SEWAGE DISPOSAL SYSTEM

MARYLAND STATE DEPARTMENT OF HEALTH

SUBDIVISION 5418 Harris Farm Lane ROAD 5304 Ten Oaks Road LOT 19A

PERMIT CARD

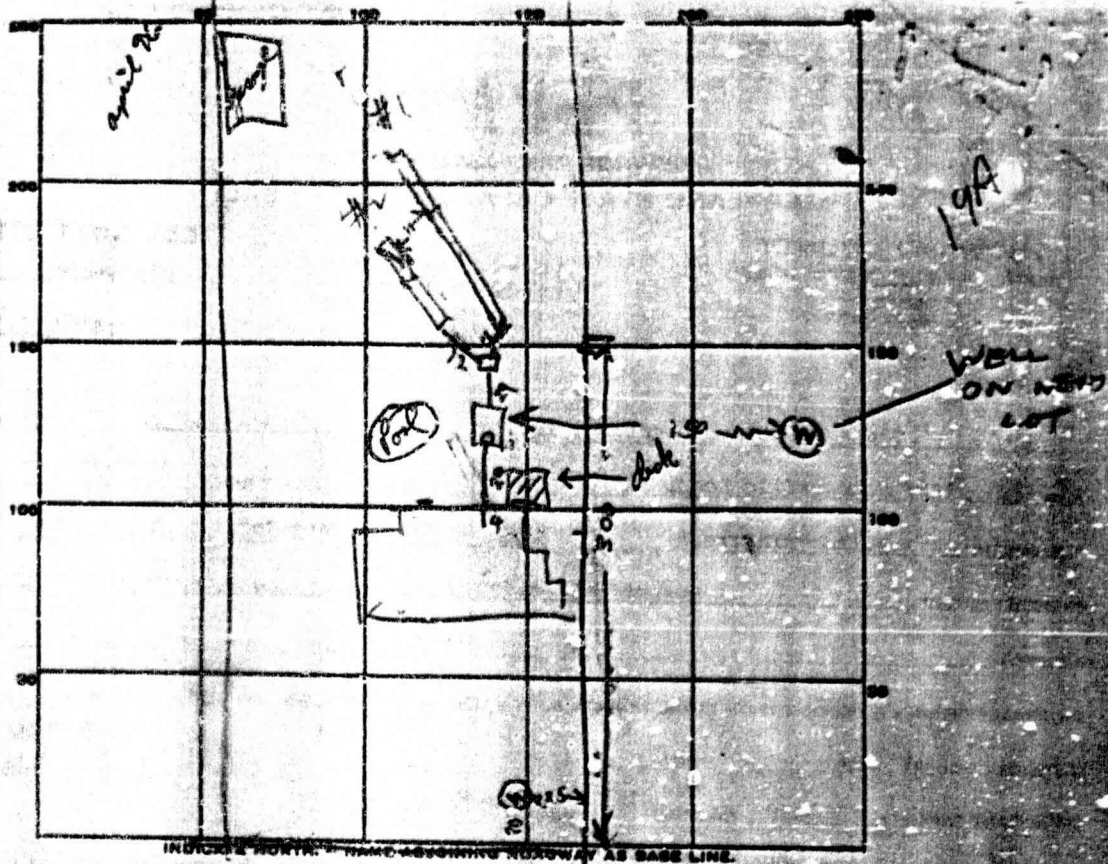
SEPTIC TANK, LEVEL 1250 ← ST
 TOP BELOW GRADE CLEANOUTS OK
 DISTRIBUTION BOX, LEVEL OK TANK TOP NOW ONLY 2 1/2 FT

1/2/86 - LOCATION OK PER PLAN. 1ST 65 FT OF FIRST TRENCH OK
 TANK SET. FINISH DIGGING TRENCH #1 DIG TRENCH #2 ADD
 STONE TO FIRST PART OF TRENCH #1 MANHOLE NEEDED ON TANK
 UNLESS GROUND CUT 1 FT OVER RMC 1/2/86 - DIG TRENCH #2
 LONGER & ADD STONE TO BOTH TRENCHES RE 1/3/86 TRENCH
 #2 DIG LONGER RE 1/3/86 632 SQ FT NEEDED BOC INSTALLED
 GROUND CUT NEAR T

11/2/86 - OK TO MAKE INLET 5 FT DEEP & ONLY
PUT IN 4 FT OF STONE
